Town of Arlington, MA Redevelopment Board

Agenda & Meeting Notice July 15, 2024

2. Discussion of 1500 Massachusetts Avenue

7:40 pm The Board will discuss issues concerning the construction of the building at 1500 Mass Ave.

2G - Open Space Diagram

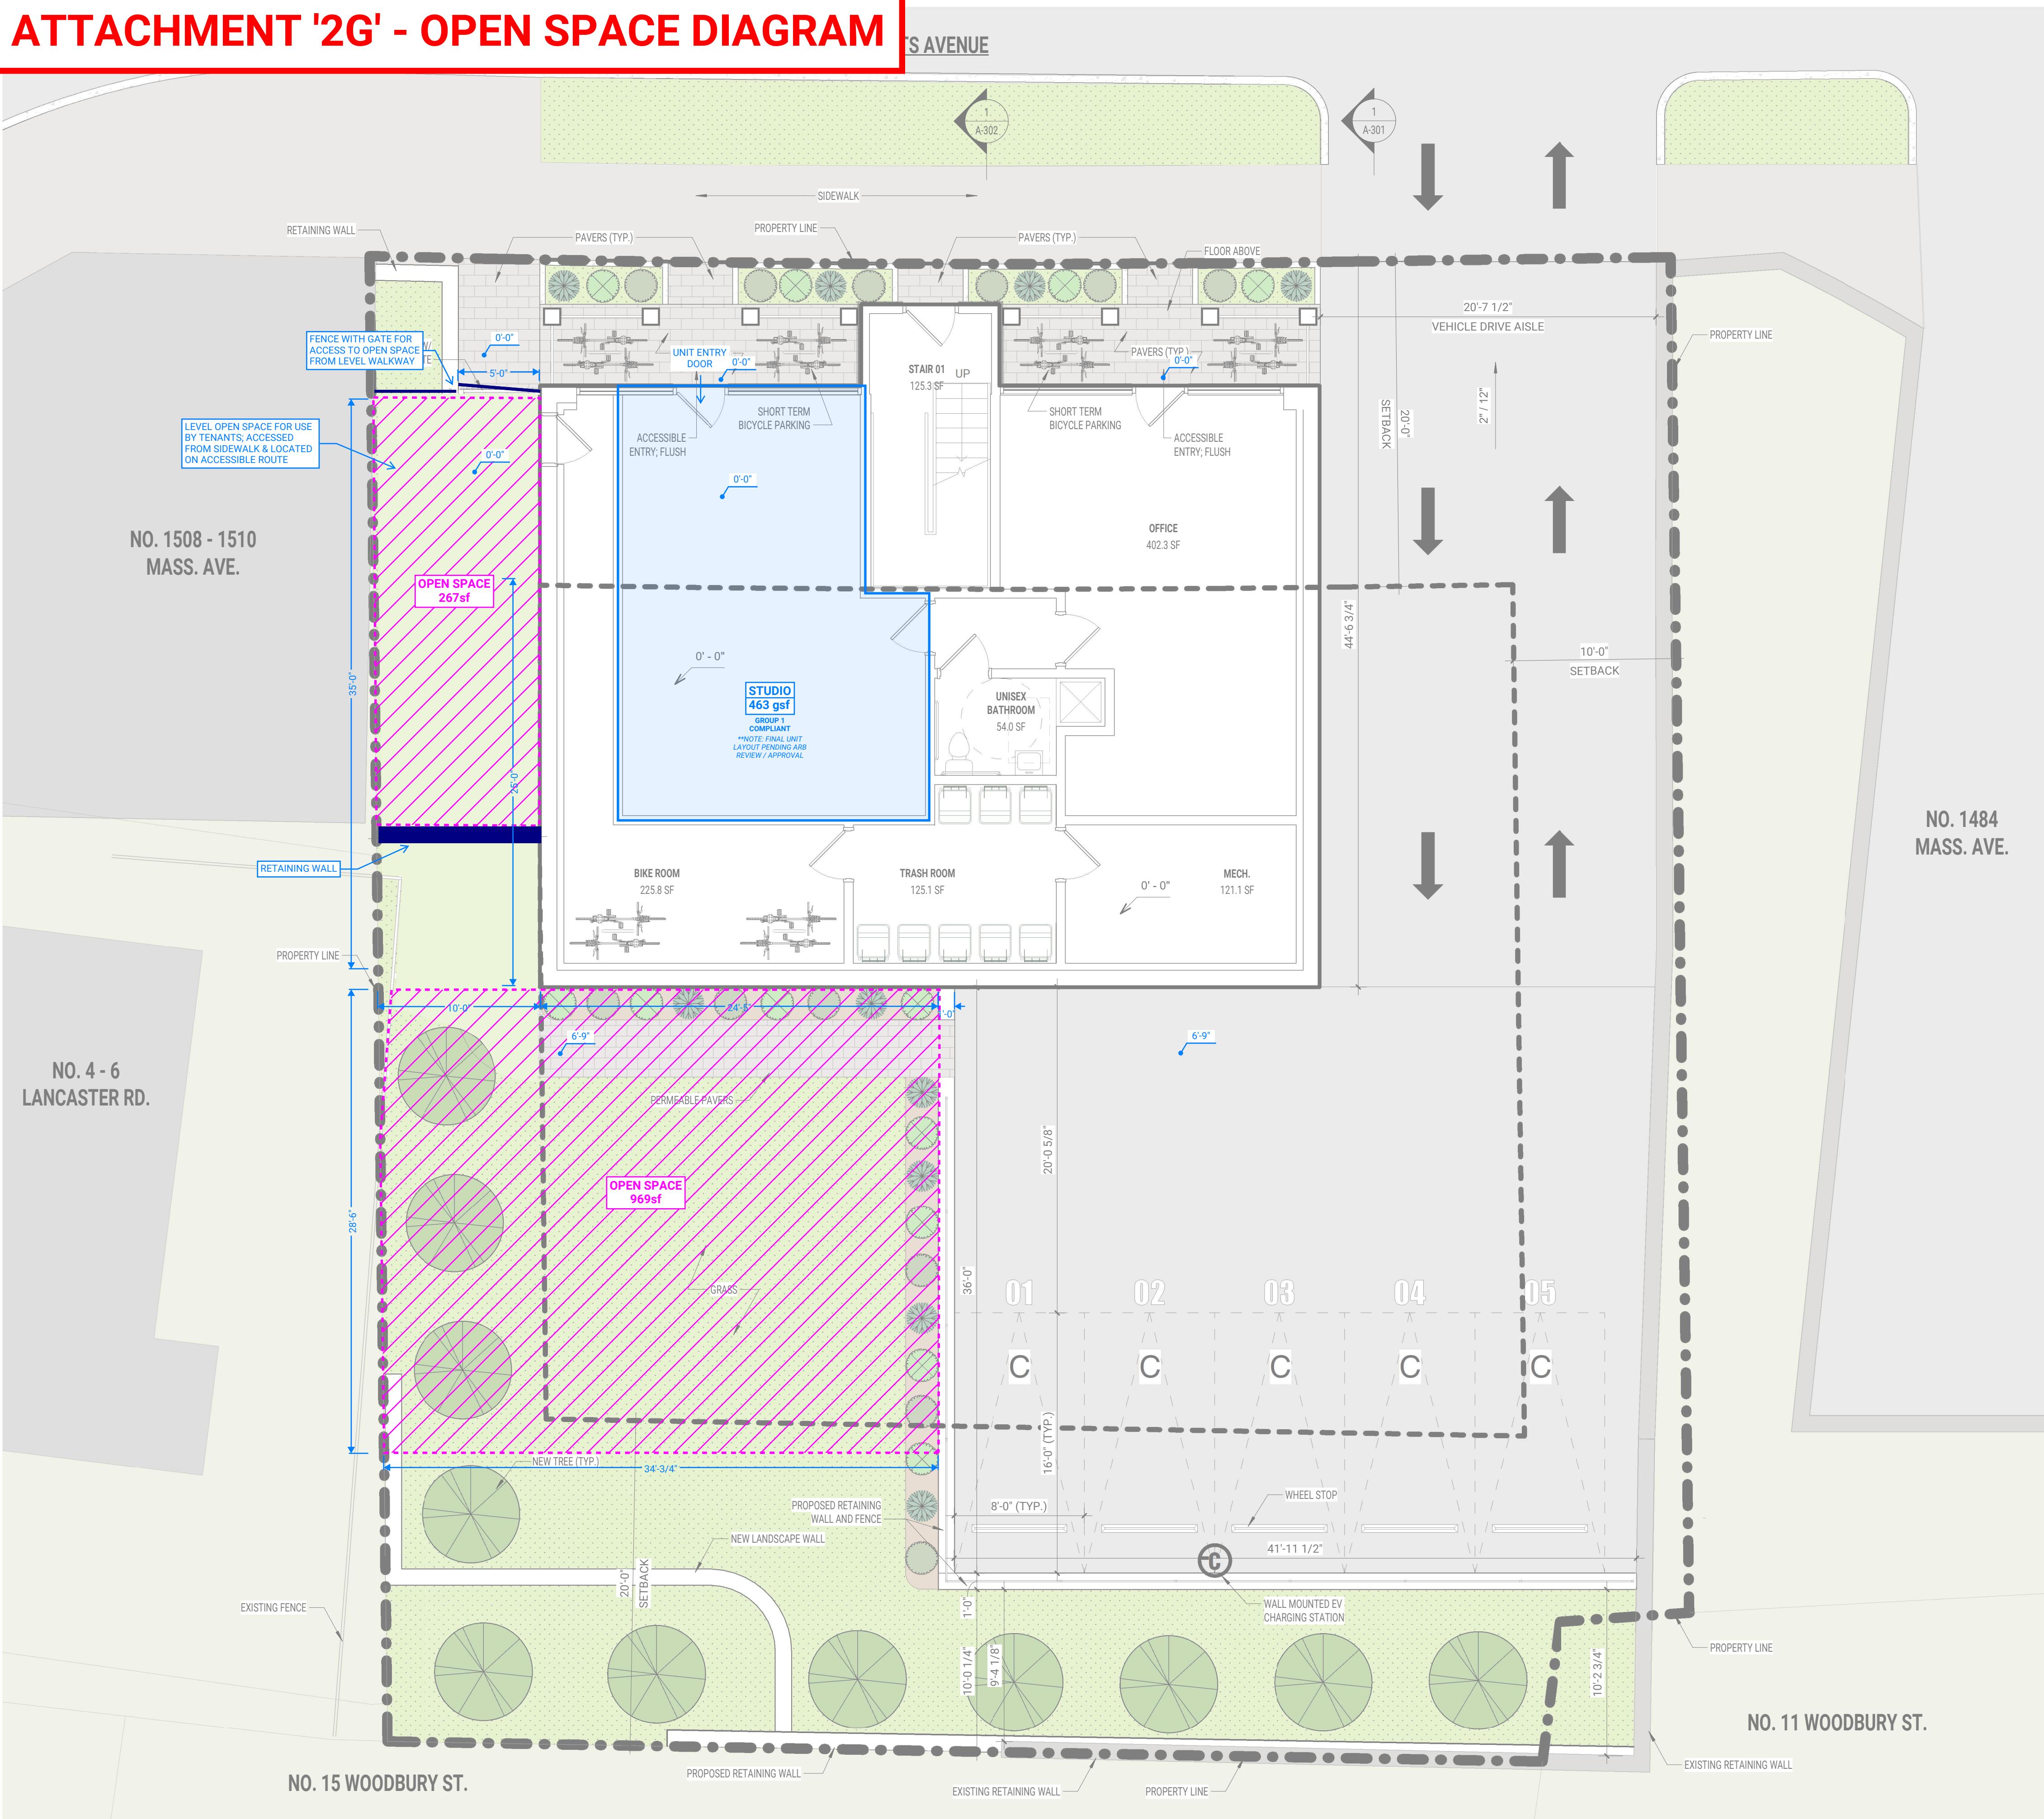
1. The ground floor office space will be reduced, and a Group 1 compliant dwelling unit will be added back into the project.
2. Additional open space will be added at the side yard of the building. This open space will be accessed from the front of the building and will be located on an accessible route.

GROUND FLOOR DWELLING UNIT DIAGRAM

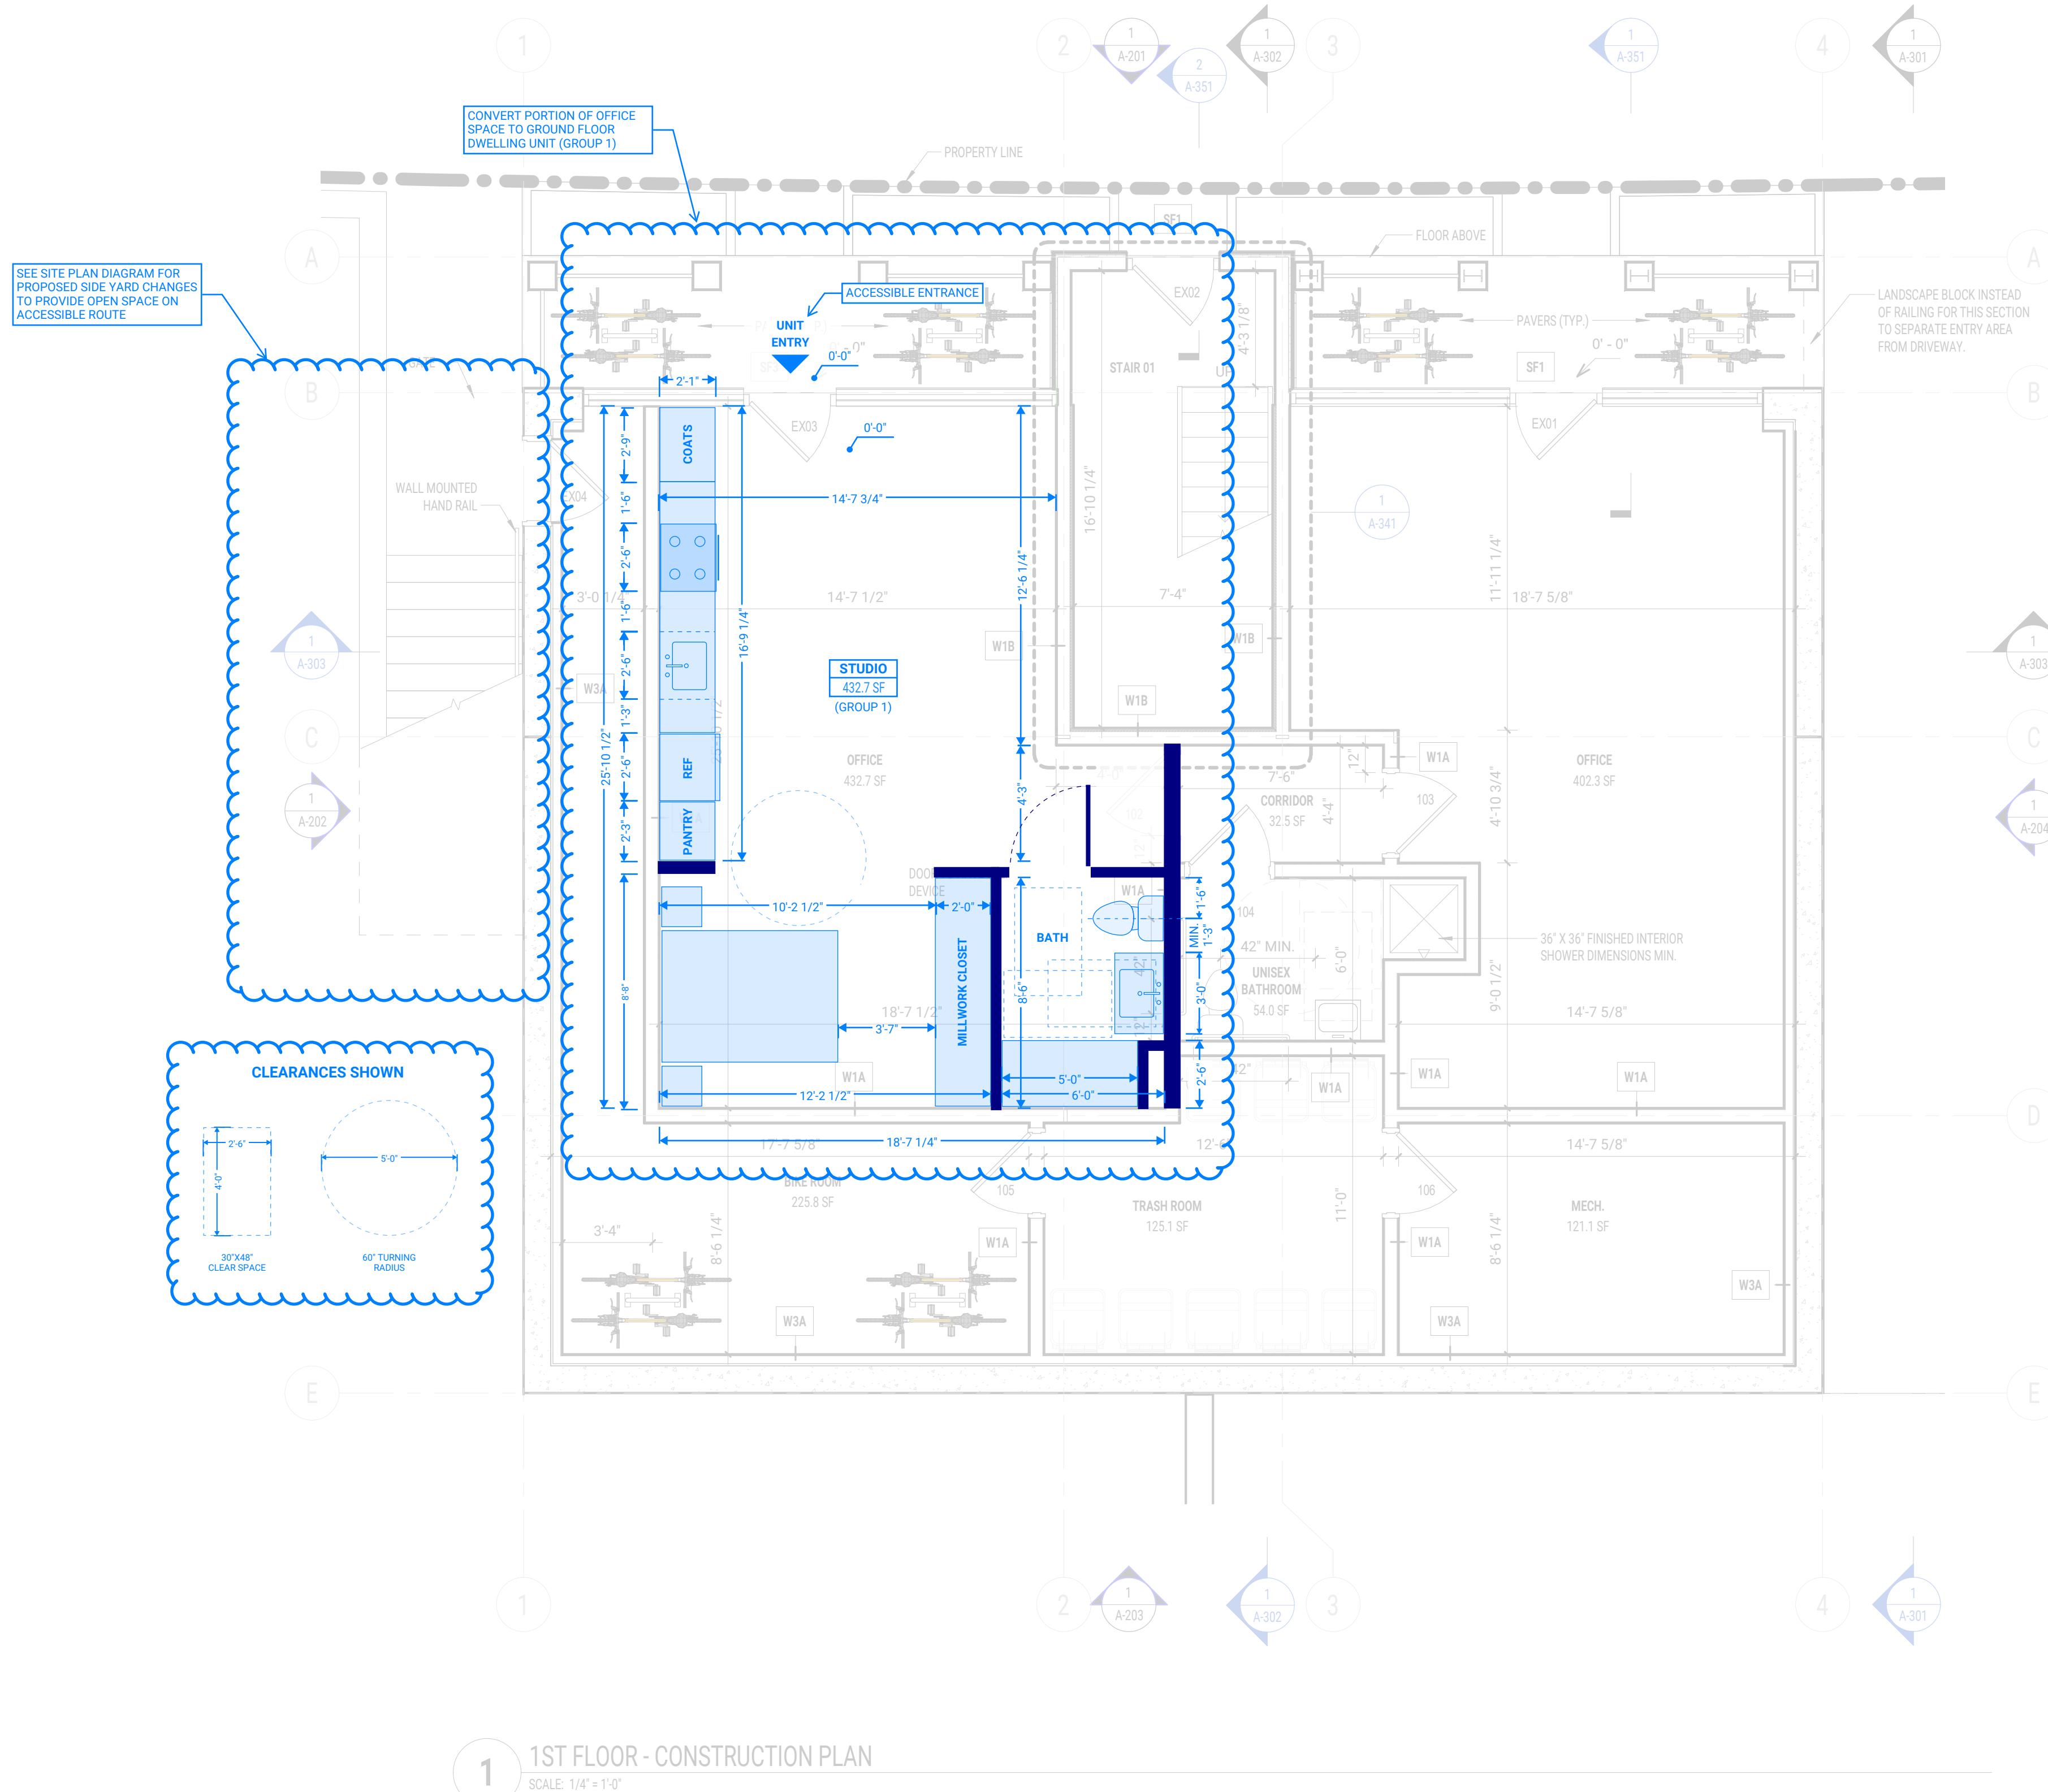
~~The ground floor office space will be reduced, and a Group 1 compliant dwelling unit will be added back into the project for compliance on sections 5.1 & 9.3 (relief on Request #1 no longer required).
Note: contingent on ARB approval~~
